AURIX™ TC23x errata sheet

Marking/Step: ES-AC, AC

10681AERRA

Figure 1 Message buffer transfer from Message RAM to OBF

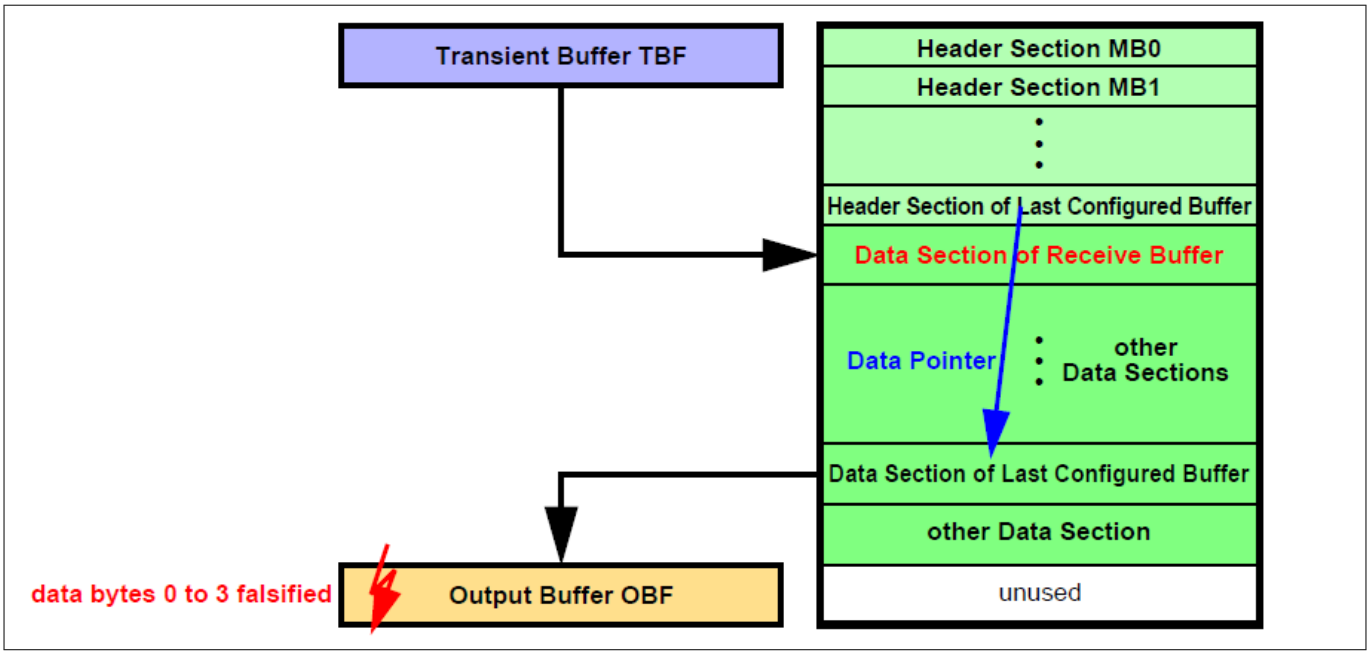
When the message buffer has its payload configured to maximum length (PLC = 127), the OBF word on address 00h (payload data bytes 0 to 3) is overwritten with unexpected data at the end of the transfer.

a) When a message is transferred from the Last Configured Buffer in the Message RAM to the OBF and PLC = 127 it may happen, that at the end of the transfer the OBF word on address 00h (payload data bytes 0 to 3) is overwritten with unexpected data (see Figure 1)

Figure 2 Message buffer transfer from IBF to Message RAM

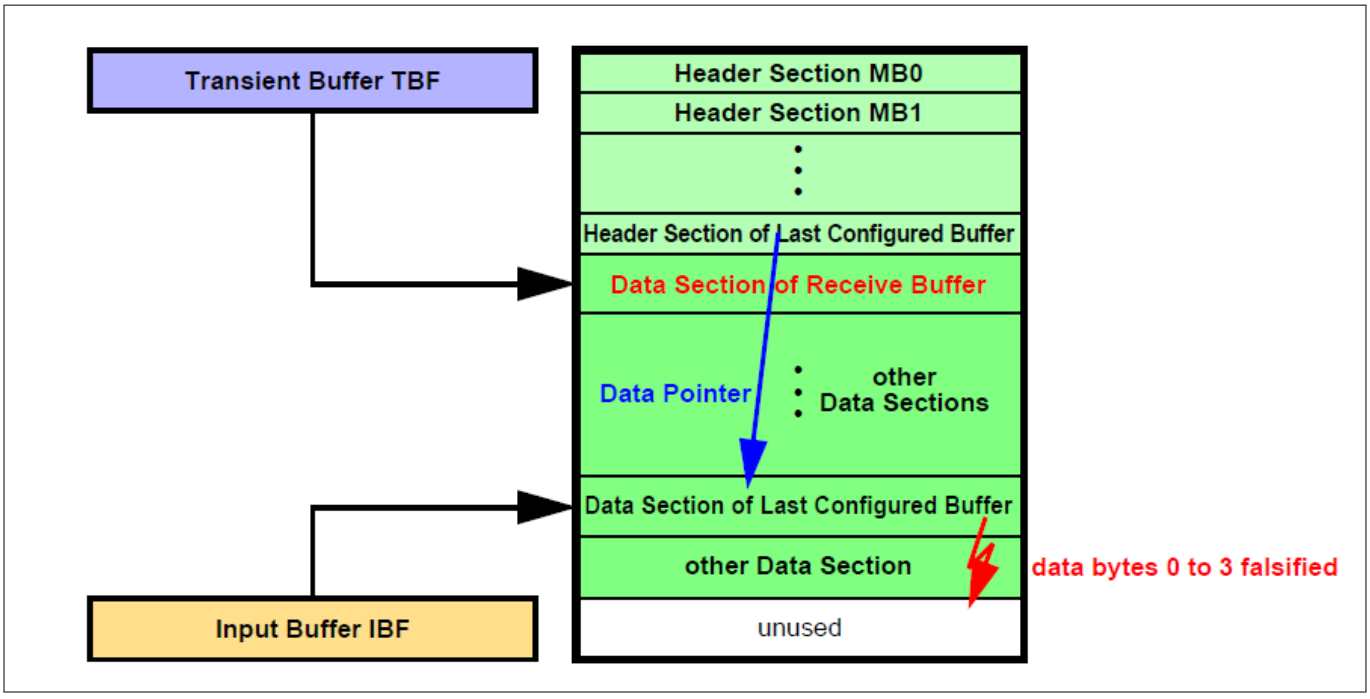
After the Data Section of the selected message buffer in the Message RAM has been written, one additional write access overwrites the following word in the Message RAM which might be the first word of the next Data Section.

b) When a message is transferred from IBF to the Last Configured Buffer in the Message RAM, it may happen, that at the end of the transfer of the Data Section one additional write access overwrites the following word, which may be the first word of another message's Data Section in the Message RAM (see Figure 2)

Figure 3 Message RAM configurations

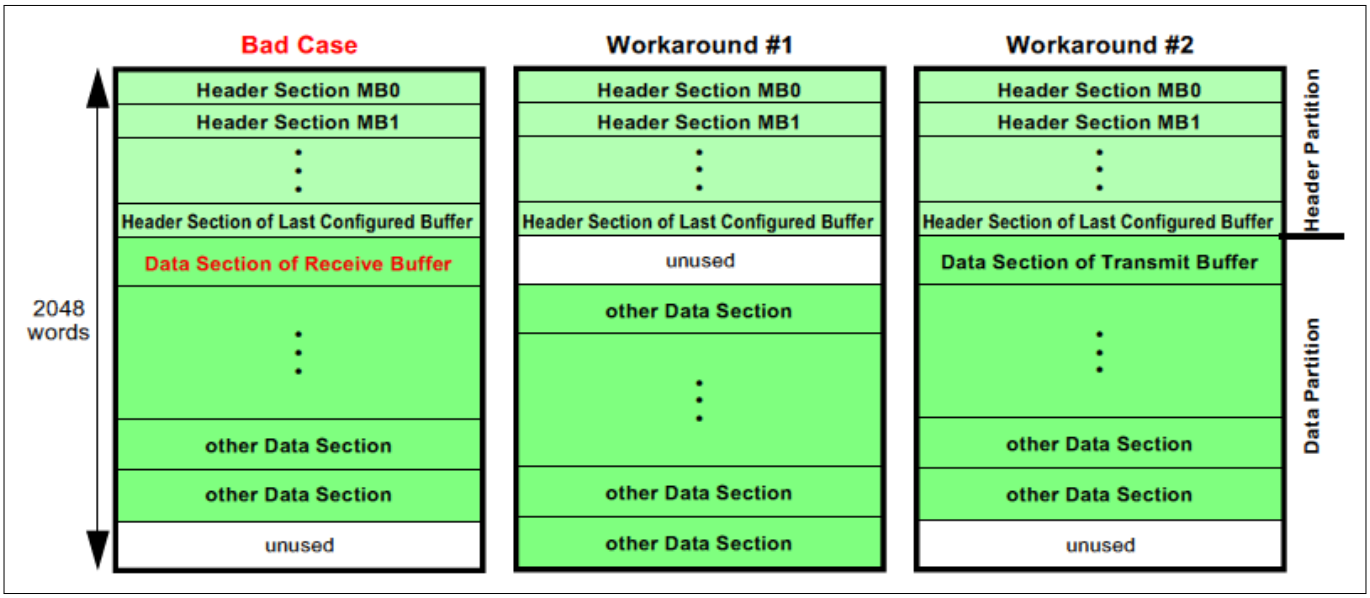
The erratum is limited to the case when (see Figure 3 “Bad Case”):

Ensure that the Data Section directly following the Header Partition is assigned to a transmit buffer.

Figure 4 Transmitter - winning CAN FD node

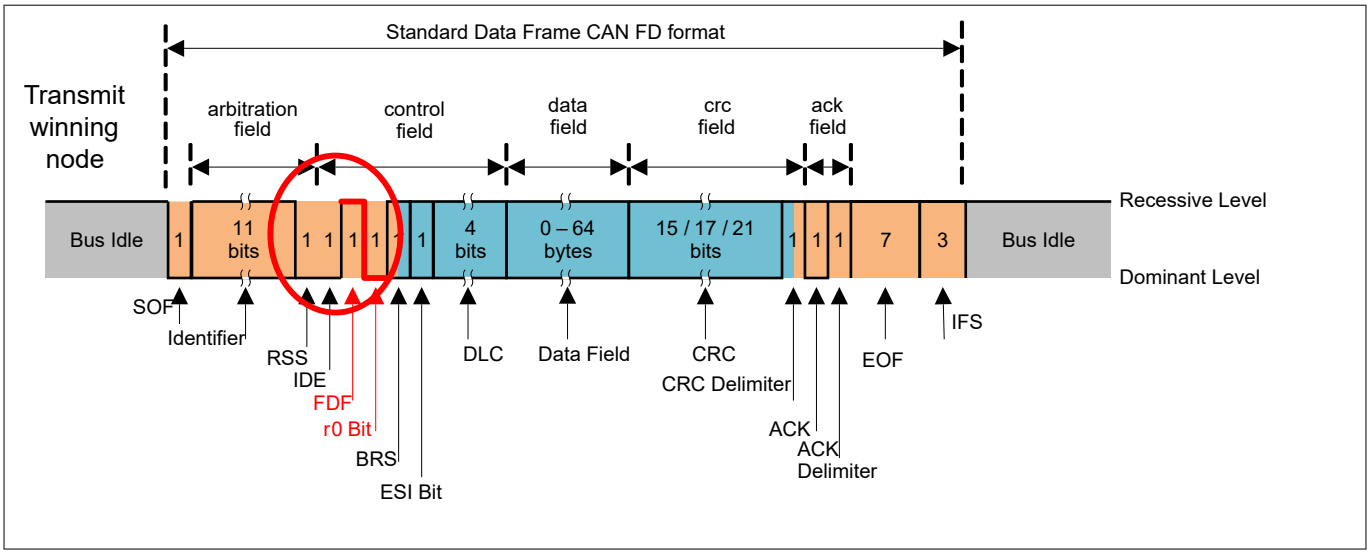
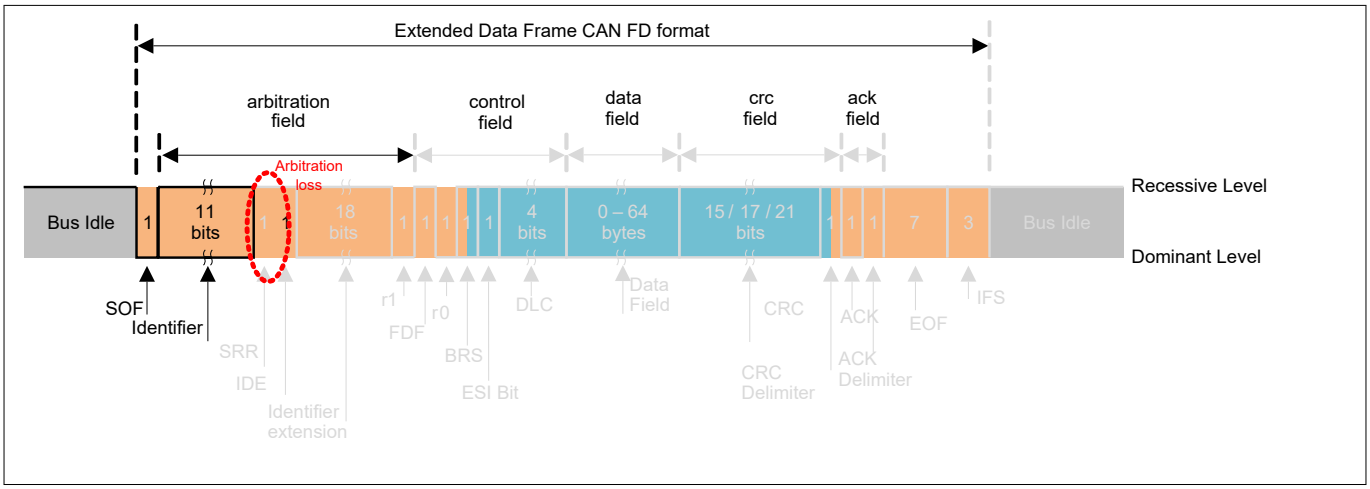
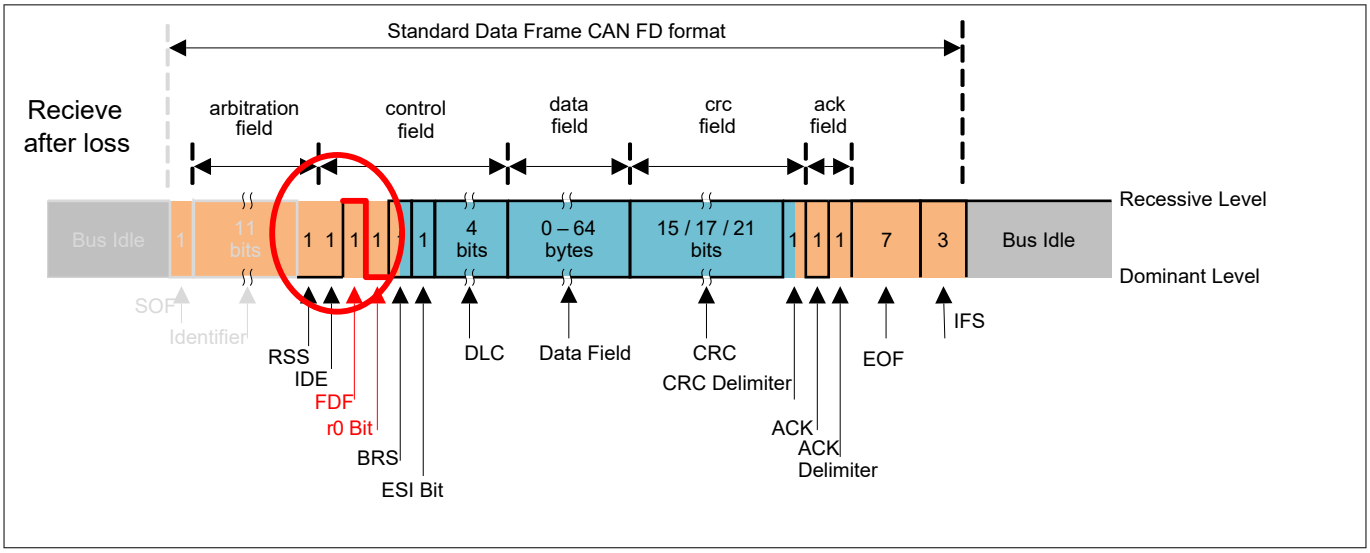
If a transmitter is losing arbitration late (for example in an extended frame - see Figure 4 the node which wins arbitration and Figure 5 the transmitting node loosing arbitration), then the FDF bit to res bit is the last chance to synchronize to the winning node (here as a receiver Figure 6 the same node as in Figure 5). A timing offset will occur between the now receiving node and the actual transmitter.

The device is producing more error frames within a network than a device with a hardsync at the FDF bit.

Figure 12 Package Outlines TQFP-144 for TC23x

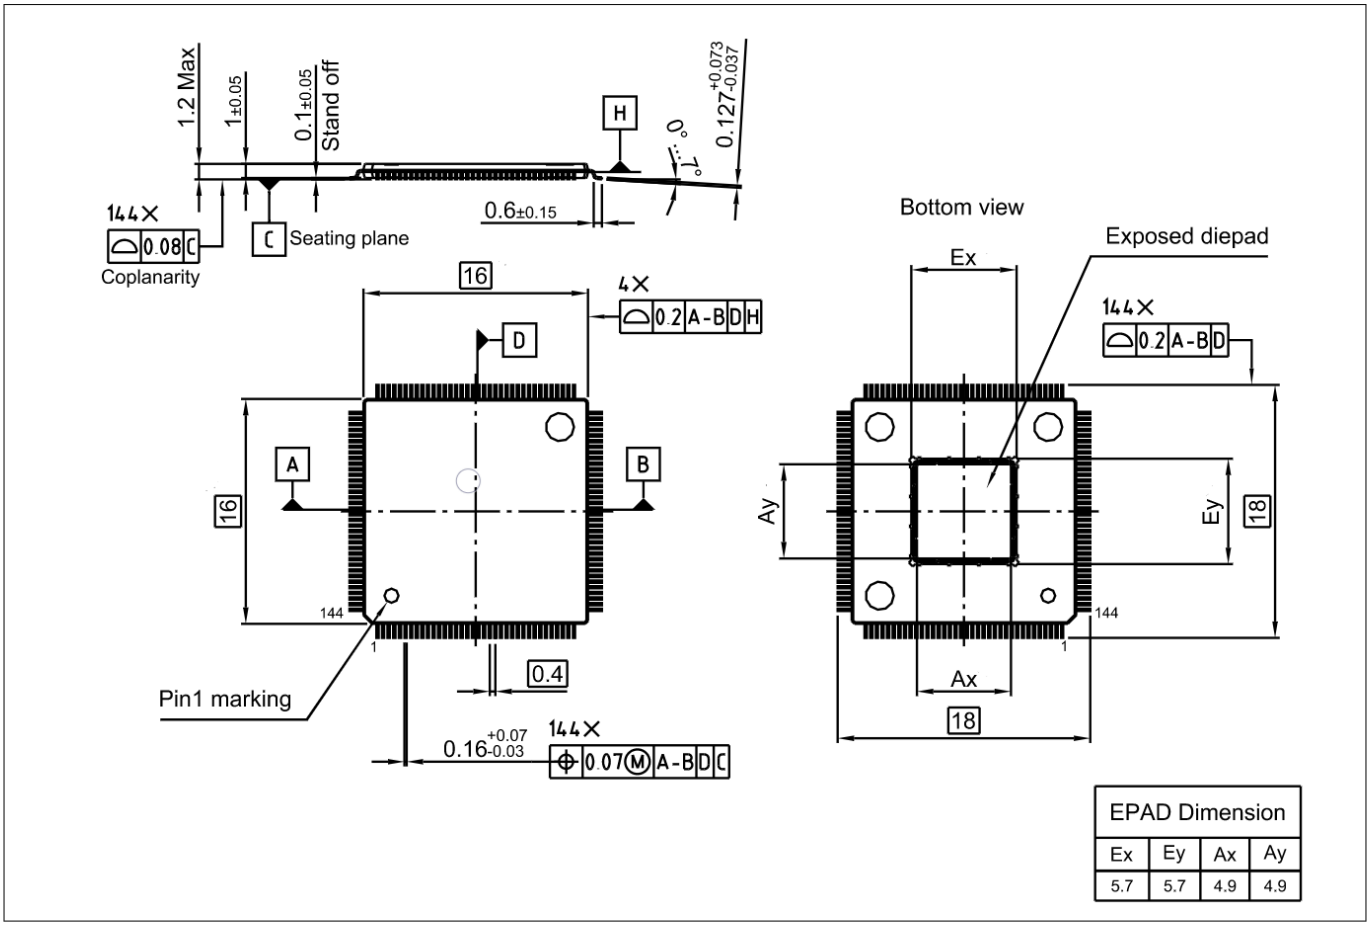
This information shall substitute the corresponding information in the TC23x AC-step Data Sheet V1.0 and in the TC23x A-step Data Sheet V1.1.

***Note**: For the exposed pad of the TQFP-144 package of the TC23x, structural corner protrusions have to be considered for purposes of system design and integration with a maximum boundary of 6.2 mm.*

Figure 15 Short Serial Message, Serial Data Encoding over 16 messages

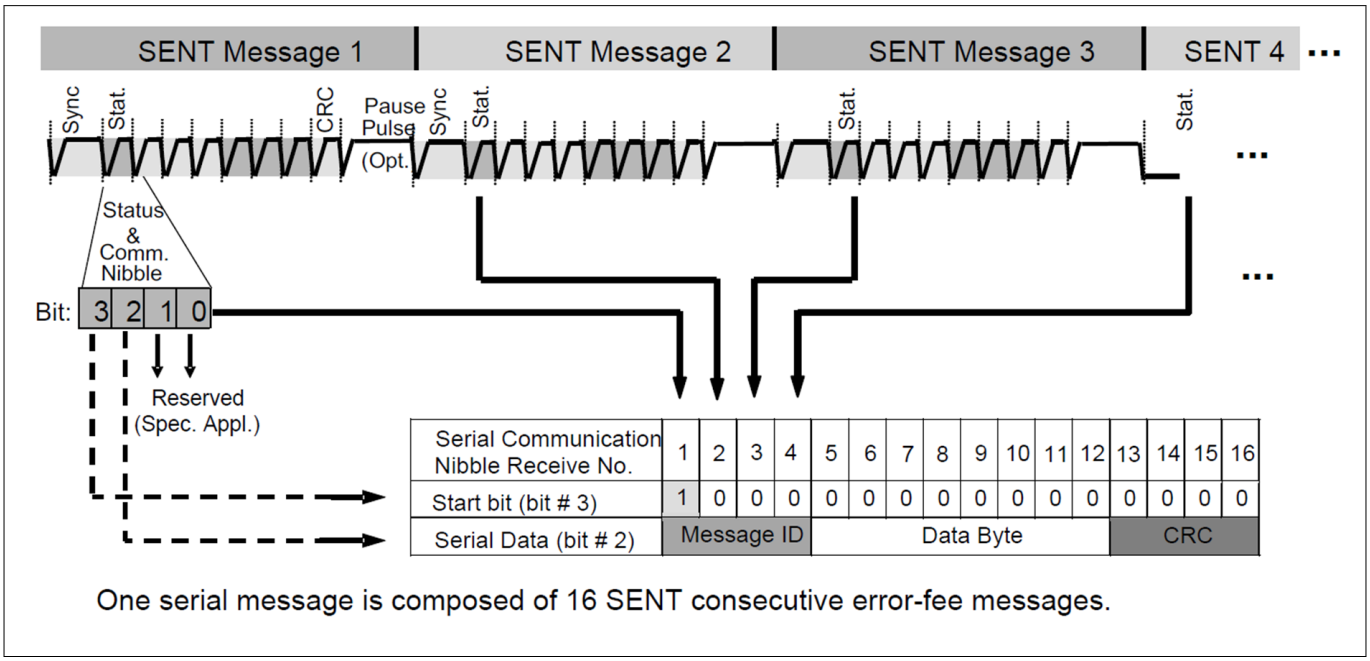
Figure 15 shows a corrected version of this figure.
